No. EL/3.2.15 (3-Phase)

MODIFICATION SHEET No. RDSO/2008/EL/MS/0352, Rev.'0' Dated 07.01.2008

Relocation of Air Suction filter on M/s ELGI make compressor type RR-20 100 mounted on WAP5, WAP7 & WAG9 class of Electric Locomotives to improve the down time of Locomotives during scheduled inspection.

MANIFOLD FOR AIR SUCTION FILTER FOR RR-20100 TYPE OF COMPRESSOR		FOR DG
RDSO. ELECT. DTE.		FIRST ISSUED
SKEL 4722		SUPERSEDES
		SUPERSEDED BY

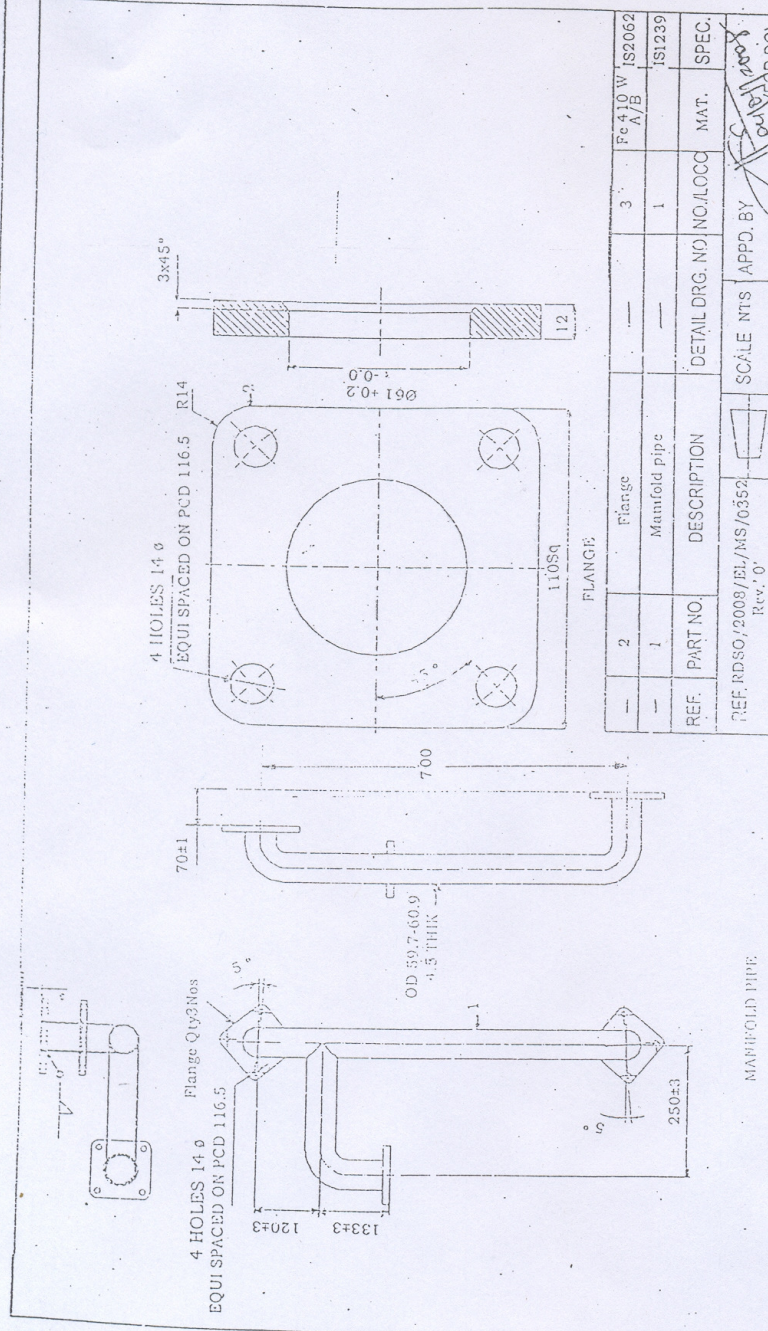
Location of Air Suction Filter is shifted from side position to top of the motor compressor unit, as shown in the enclosed Drawing No. 07 03 0065 0 (G.A. of reciprocating air compressor package) of M/s. ELGI resulting in following advantages:-

Manifold suction pipe and Flange as per RDSO's Drawing No. SKEL – 4722.

Manifold for Air Suction Filter of RR20100 Type of Compressor to RDSO's drawing No. SKEL 4722.
